To: California Coastal Commissioners and staff

Re: Application 9-15-0228 Coastal Application 9-15-0228, Southern California Edison Company, Construct and operate an Independent Spent Fuel Storage Installation (ISFSI) to store spent nuclear fuel from SONGS Units 2 and 3

Estimated Cooling Time for PWR fuel to Reach Specified Thermal Power, as a Function of Canister Size and Burnup

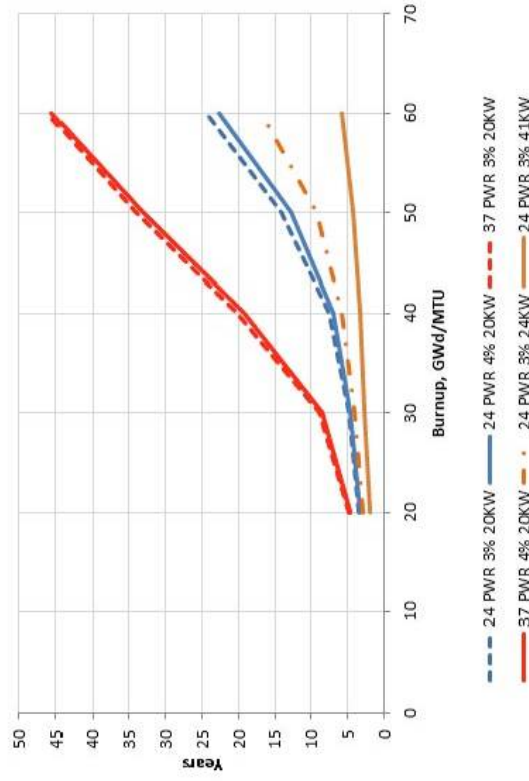
The system may require up to 45 years of cooling before transport to permanent storage (due to the high number of fuel assemblies in one canister combined with the enriched high burnup fuel). If Edison used a cask or canister with only 24 fuel assemblies, it would result in decades less required cooling time. The existing NUHOMS canisters hold 24 fuel assemblies. See Cooling Chart (page 9). See also <http://www.nwtrb.gov/meetings/2013/april/boyle.pdf>
